OWNER CHANGE ORDER

NO.: 007

TITLE: OCO #007 - PCI: # 28, #29, #31, #32, #34 & #35
PROJECT: Magnolia Science Academy
TO: Magnolia Educational and Research Foundation
250 E. 1st St., 1500
Los Angeles, CA

DATE: 05/15/2019
PROJECT NO.: 18049
CONTRACT: 18049

PARKING CHARGING STATIONS - DETAILS

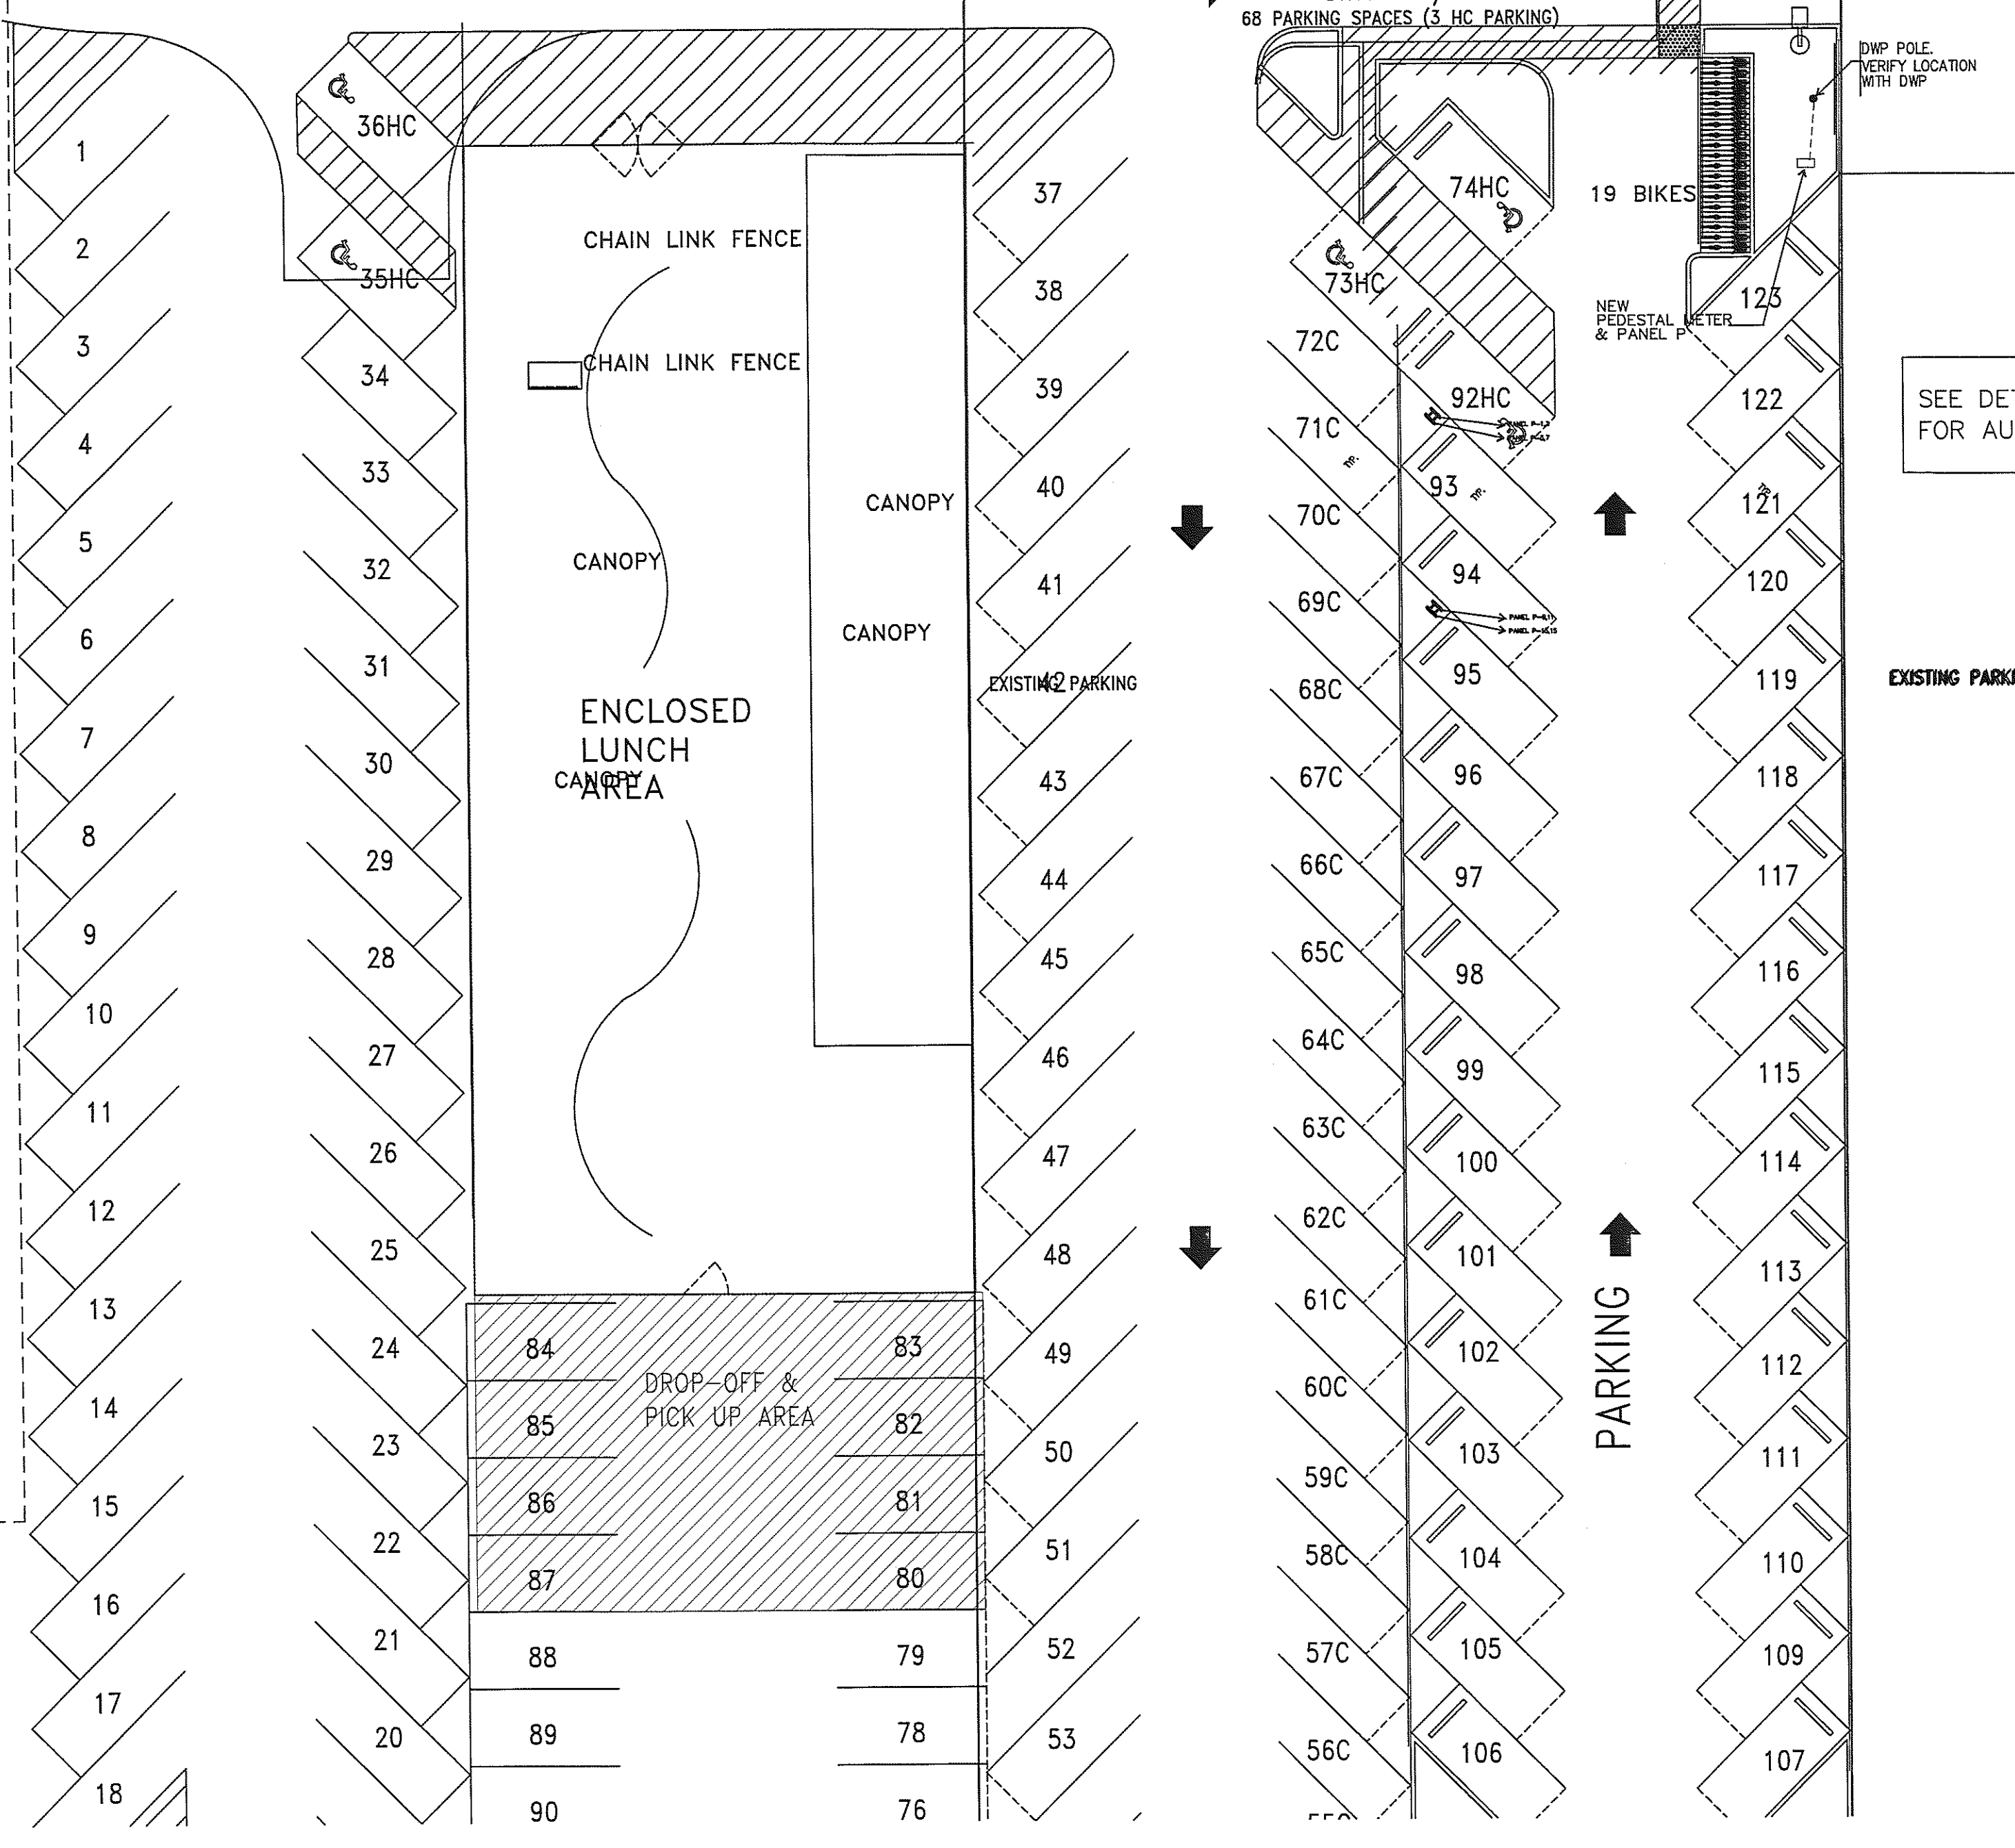
This Potential Change Item (PCI) tracks costs associated with the added labor, materials, and equipment required to install the added LADWP electrical pole not previously included in our scope. Reference E2.1 for site plan.

DWP has advised that the Owner needs to install a new pole to feed the new electrical equipment (LADWP page 7-28 Design & Installation Guide for Overhead Services, 0-600 volts sheet)

1 FIRST FLOOR CONSTRUCTION PLAN
SCALE: 1/8" = 1'-0"

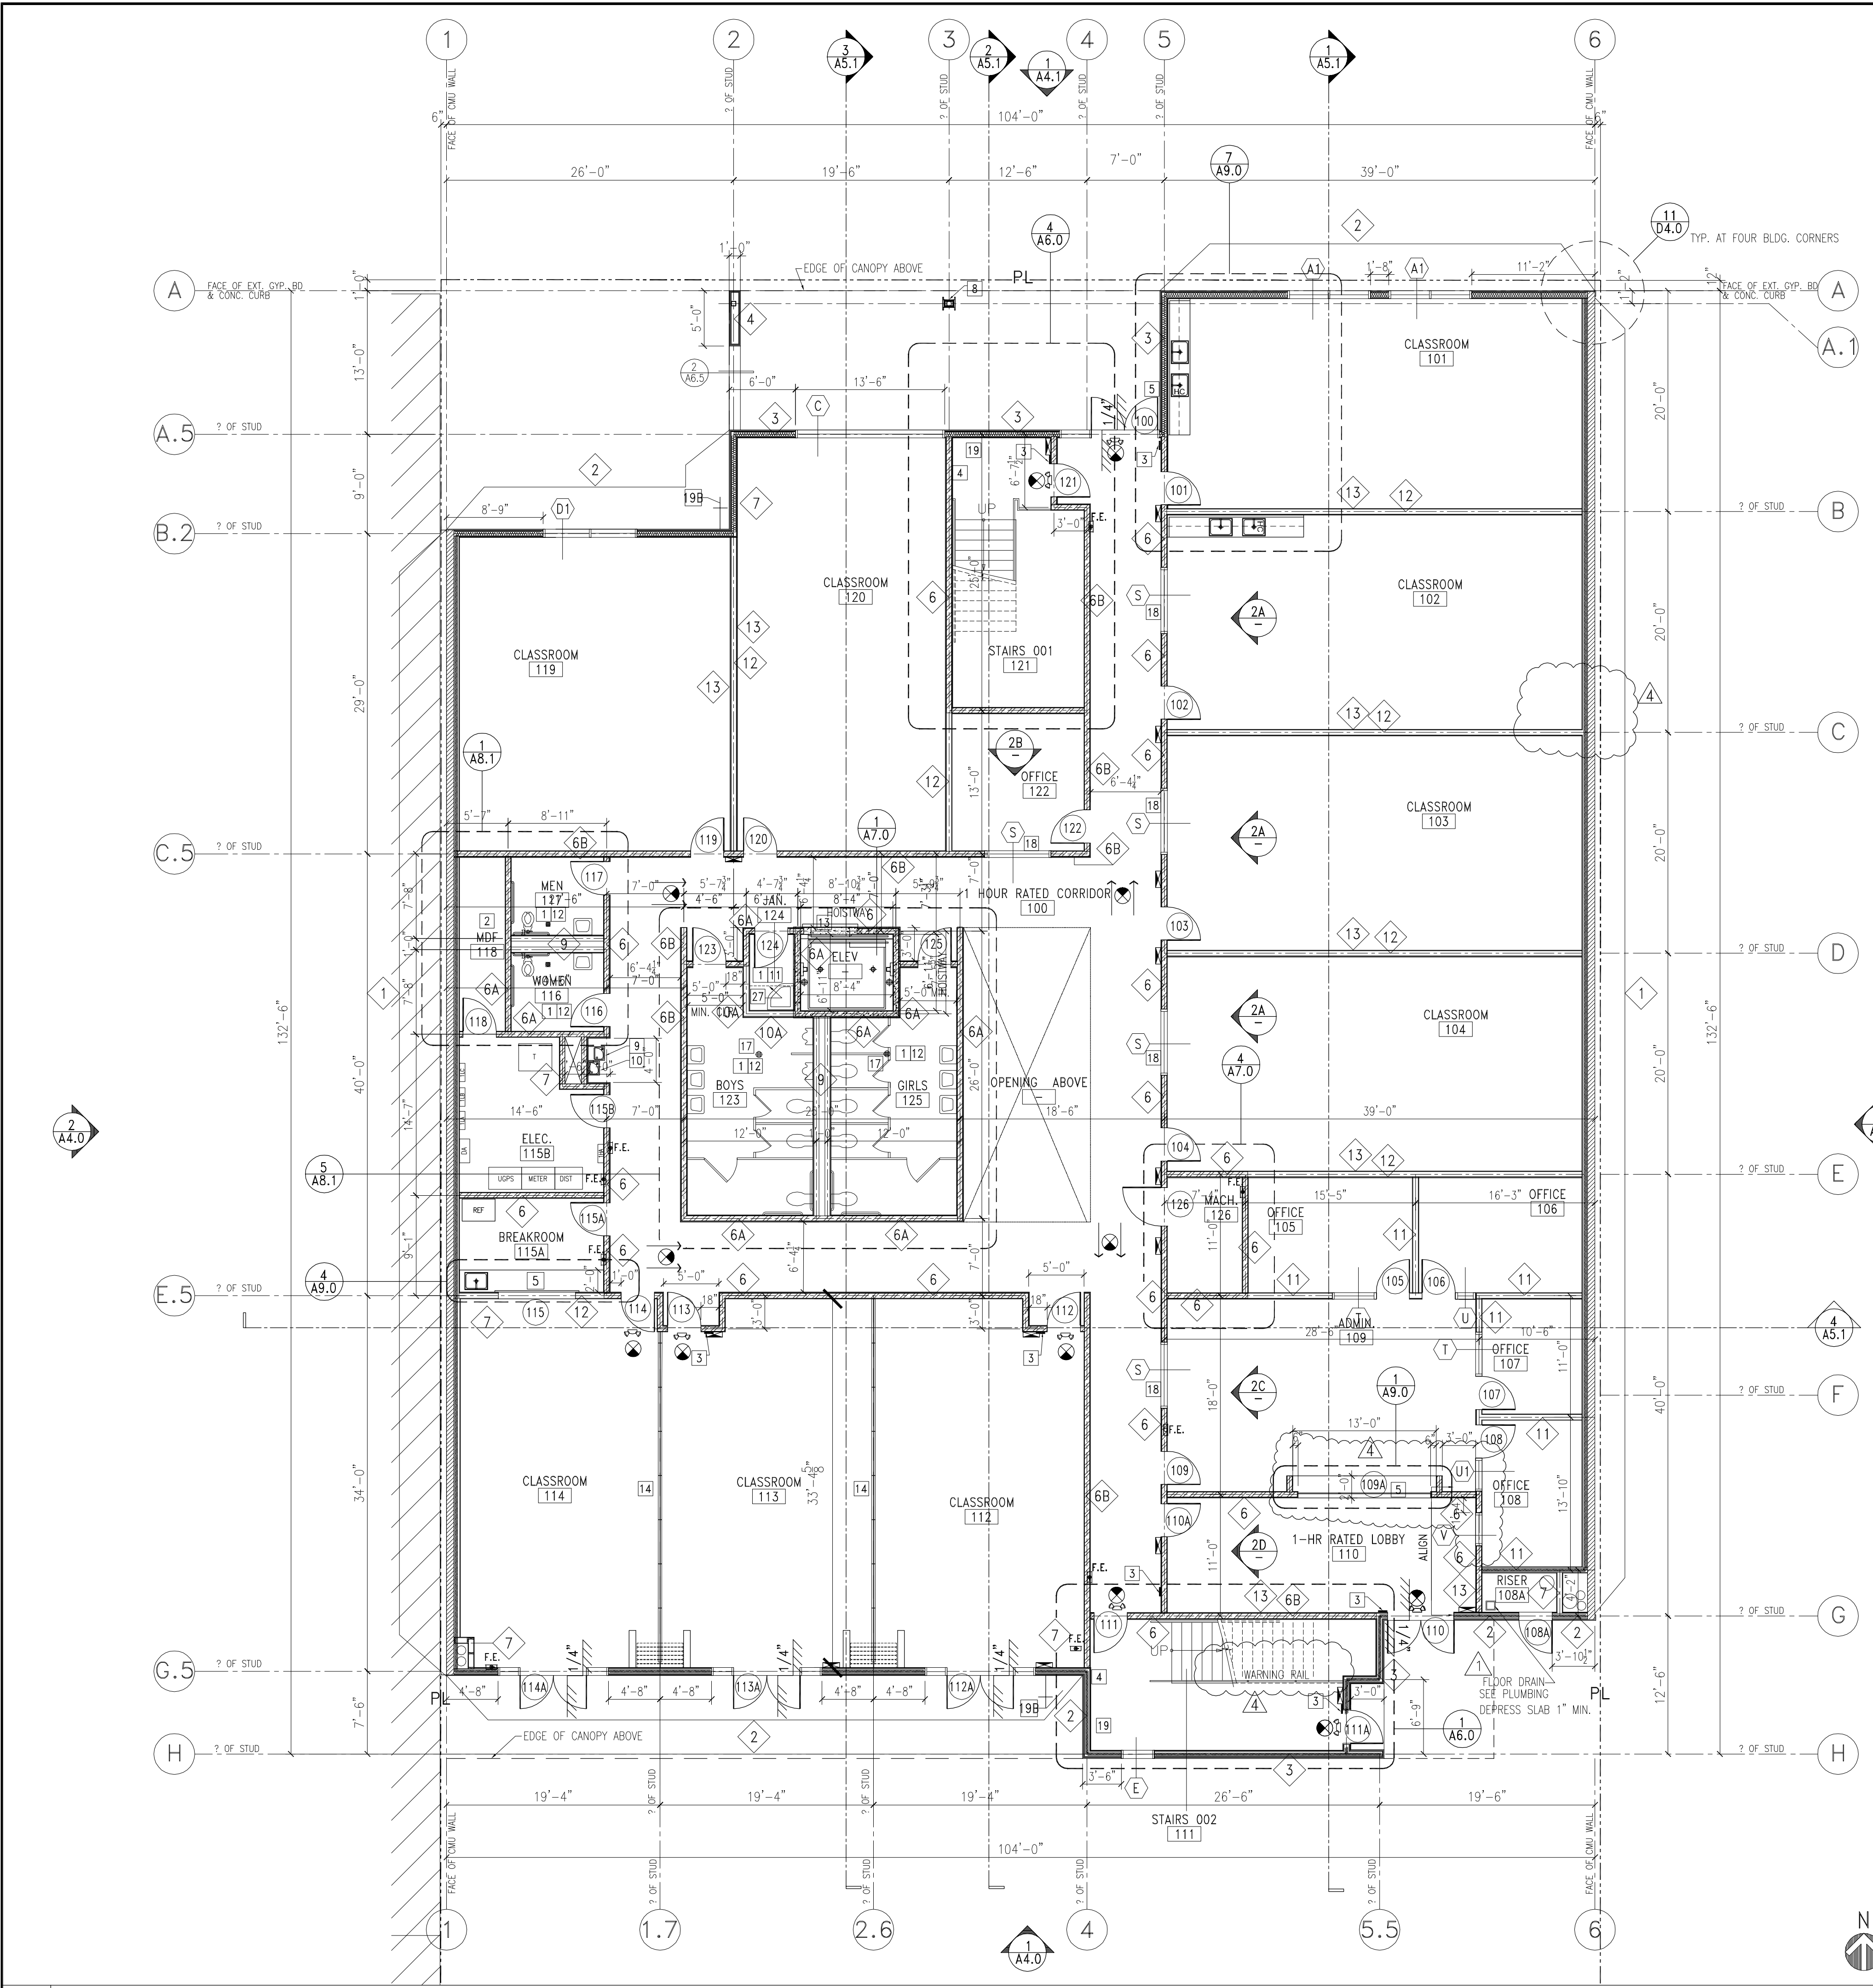
INCLUDES:
 - PERMEABLE CONCRETE AT NORTH PORCH
 - REMOVE 2 LIGHT POLE AND MOUNT SITE FLOOD LIGHTS ON THE BUILDING ELEVATIONS
 - ADD SITE SLOPE AT THE OUTDOOR AREA SOUTH OF THE BUILDING - SHOWN IN 3 SECTIONS.
 - REMOVE THE WEST FENCE.
 - SHOW TRENCH DRAIN PER CIVIL DESIGN.
 - USE MANUAL SLIDING GATE AT THE ALLEY.

PARTIAL ROOF CONSTRUCTION PLAN
SCALE: 1/8" = 1'-0"

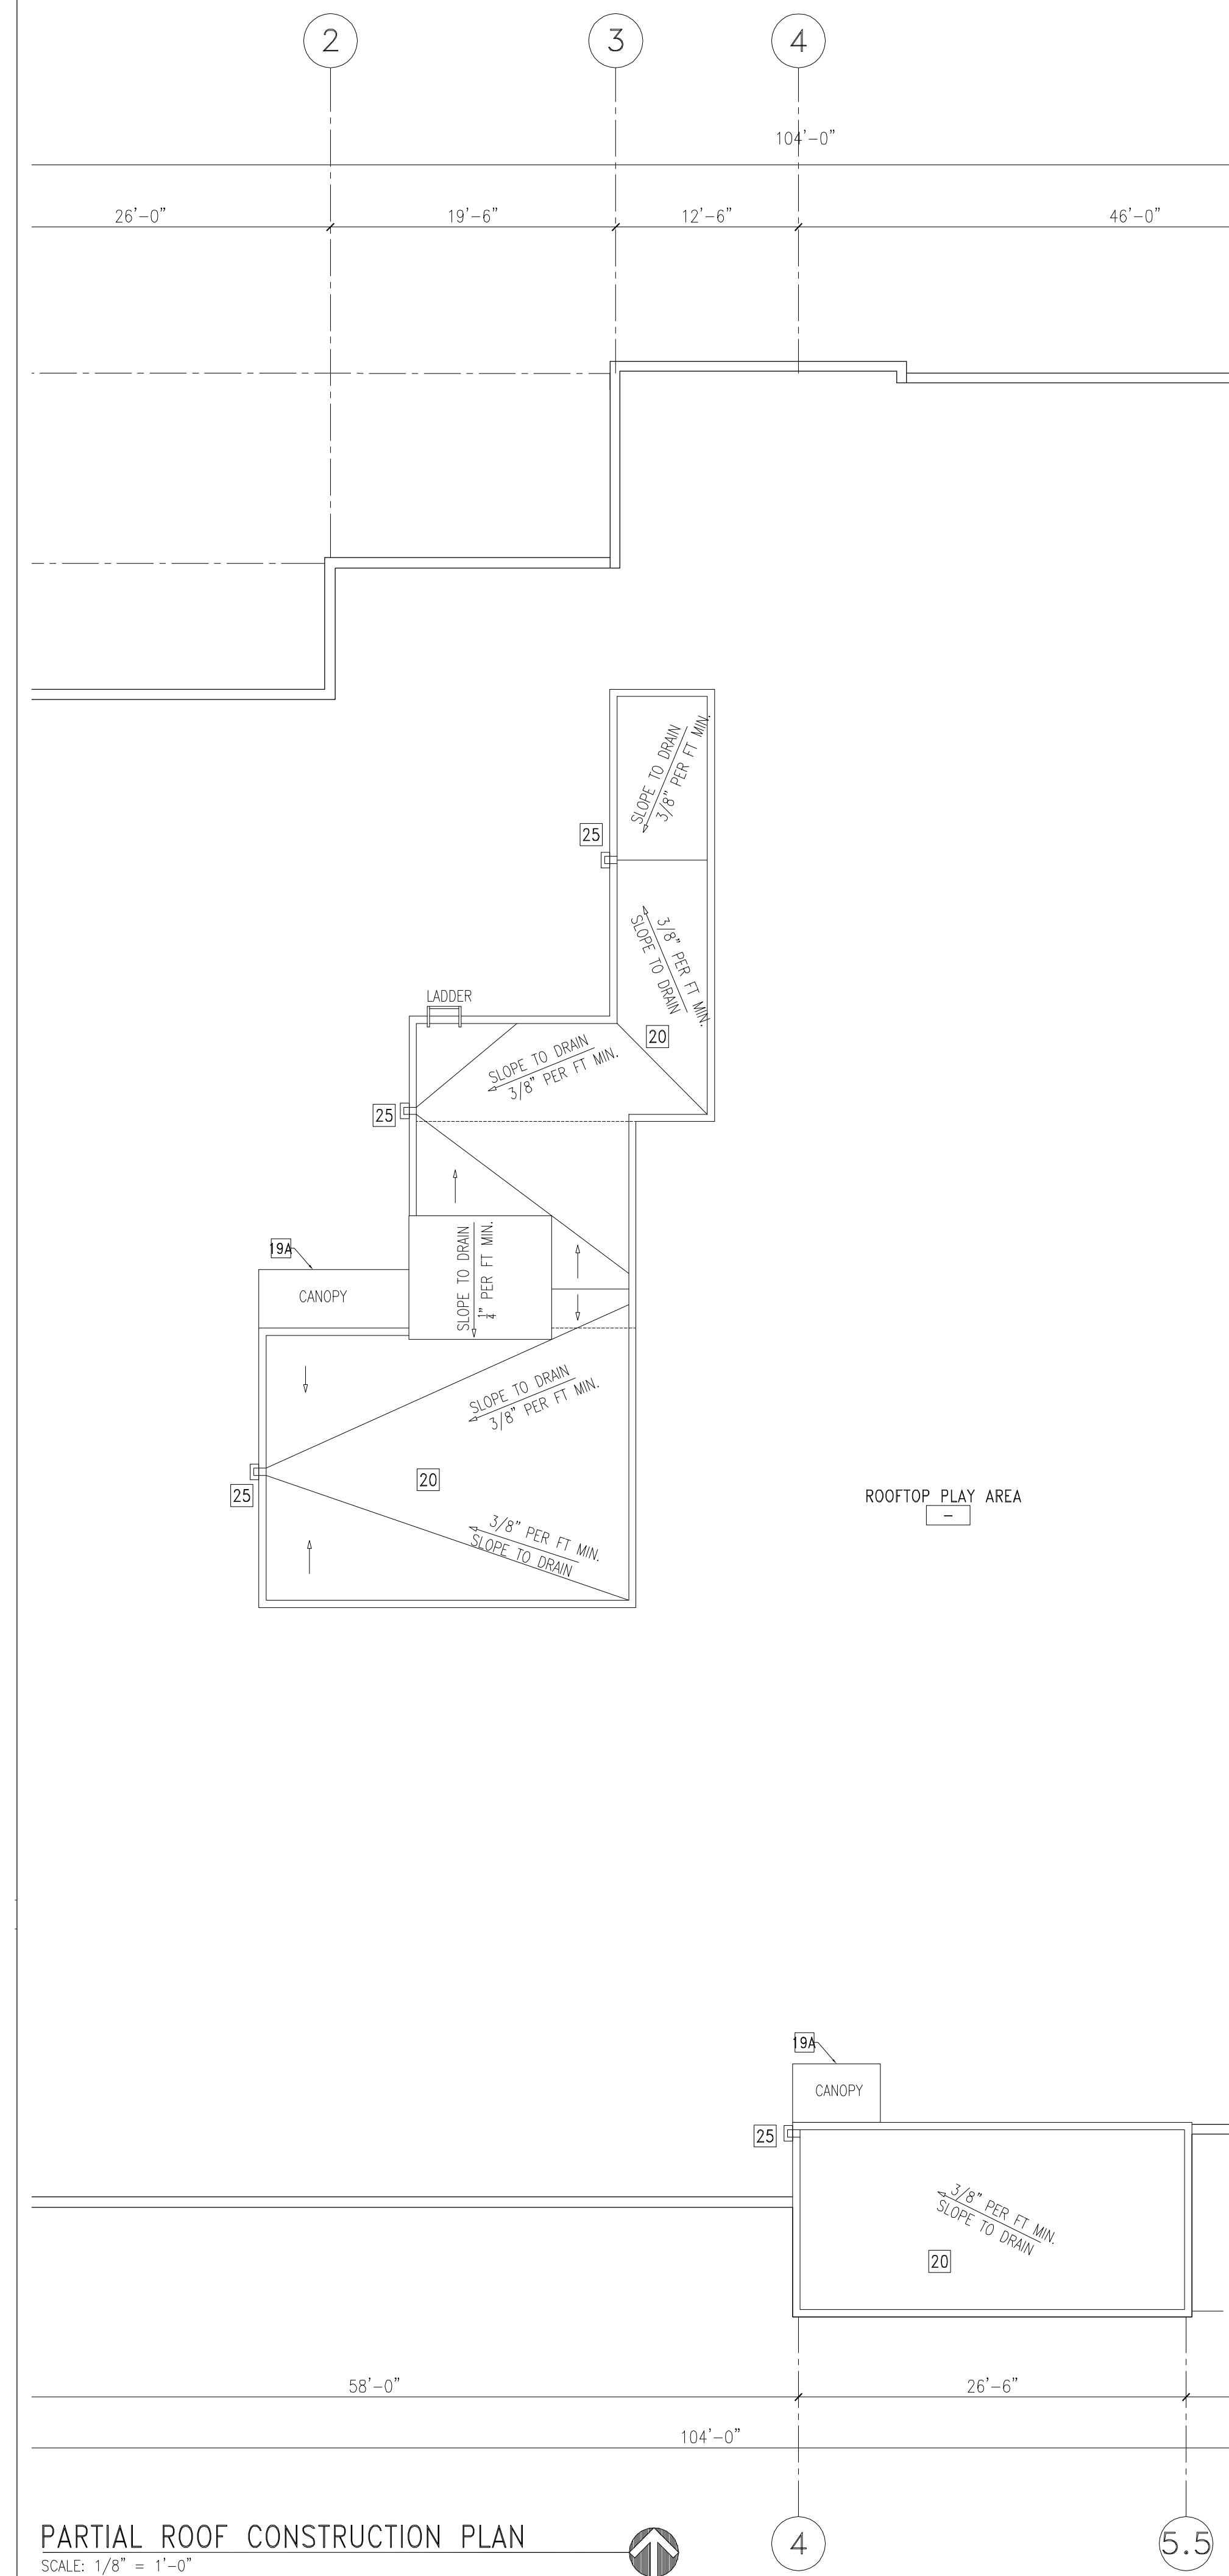
- INCLUDES:**
- REDUCE CANOPY-3 TO MATCH WITH ELEVATION
 - ADD WALL MOUNTED FLOOD LIGHT
 - SHOW PARAPET BRACING AND ADD DORMER VENTS
- ADD CRICKET ON ROOF DECK, CLARIFY SURFACE DRAIN PATTERN AND REPOSITION THE DRAINS**
- ADD DECK COATING**
